ADDRESS . . : 131 KIMBROUGH DR SUBDIV: WOODSHIRE PH 5
CONTRACTOR : CAVINESS LAND DEVELOPMENT PHONE : (919) 481-0503
OWNER . . : CAVINESS LAND DEVELOPMENT PHONE : (910) 481-0503
PARCEL . . : 01-0536-06- -0028- -15-
APPL NUMBER: 09-50022370 CP NEW RESIDENTIAL (SFD)
DIRECTIONS : WOODSHIRE #175
TAKE 27W APPROX 8MI. T/L ON NURSERY
ROAD, GO APPROX 3MI. T/L ON WOOD POINT,
GO APPROX 0.3MI, T/R ON KIMBROUGH.
T/S: 06/29/2009 11:17 AM RDCONTE ---

PERMIT: CPSF 00 CP * SFD

Re: J92881

Cav. Land / Lot 175 Woodshire

Job J92881	Truss FT2	Truss Type FLOOR	Qty 1	Ply 1	Cav. Land / Lot 175 Woodshire Job Reference (optional)	E6450454
---------------	--------------	---------------------	----------	----------	---	----------

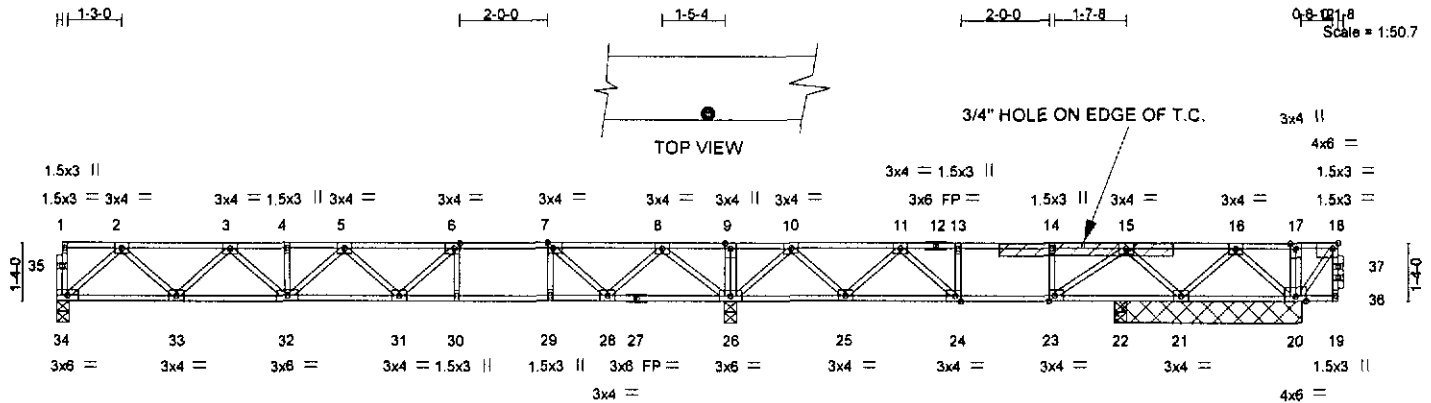
APPLY 2X4 X 4' - 0" SPF NO.2 SCAB TO ONE SIDE OF TRUSS, CENTERED ON DAMAGE, WITH CONSTRUCTION QUALITY ADHESIVE AND 1 ROW OF 10d (3" X 0.131") NAILS SPACED 3.0" O.C.
